MEGARAD, INC.

Re: Docket No. 030-34615
Control No. 125298

APPLICATION FOR RADIOACTIVE MATERIAL LICENSE

Responses to Judith A. Joustra's queries of June 10, 1998

Shooting Cell

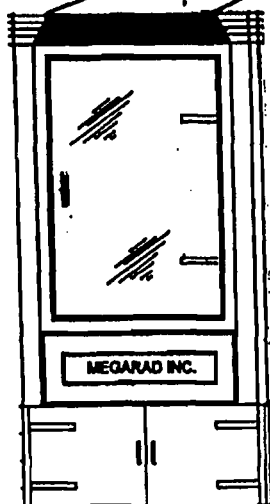
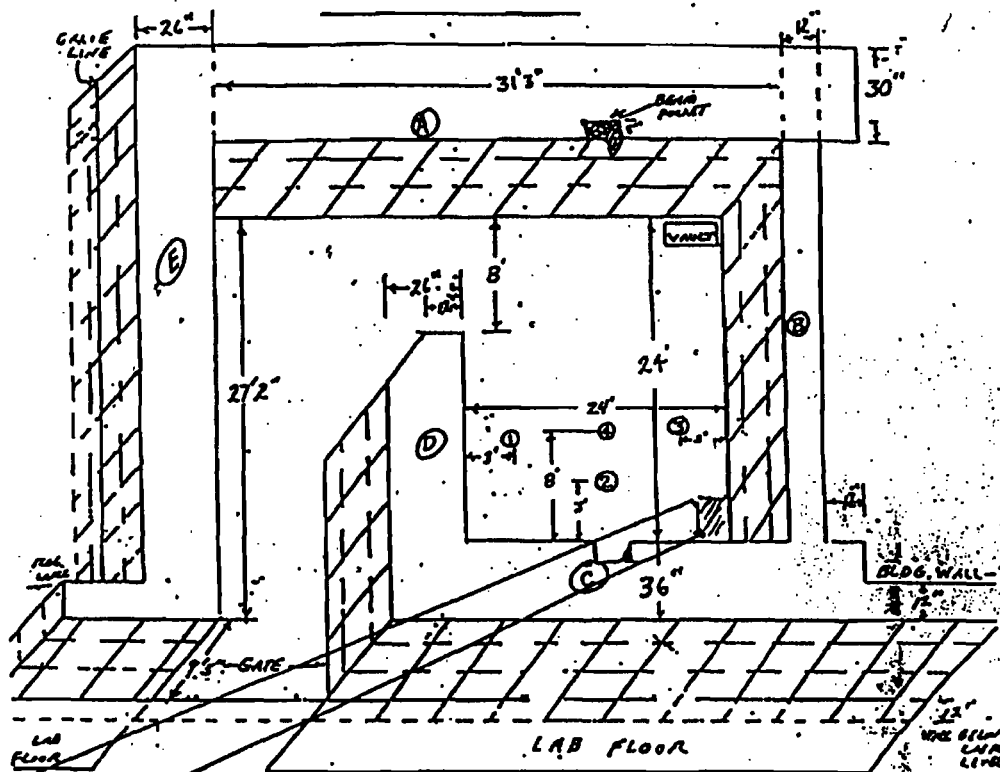
3. Radiation levels on the outside of Megarad's storage facility at 277 West Main Street, Niantic, CT will be less than 1 mR/h from Megarad's radiographic exposure devices in storage. The remaining information requested in Query 3 is in Attachment C.

- NOTES:
1. (B) Wall earth backed and under asphalt
 2. Markers ①, ②, ③, & ④ denote source location during room survey.
 3. Roof thickness is 36".
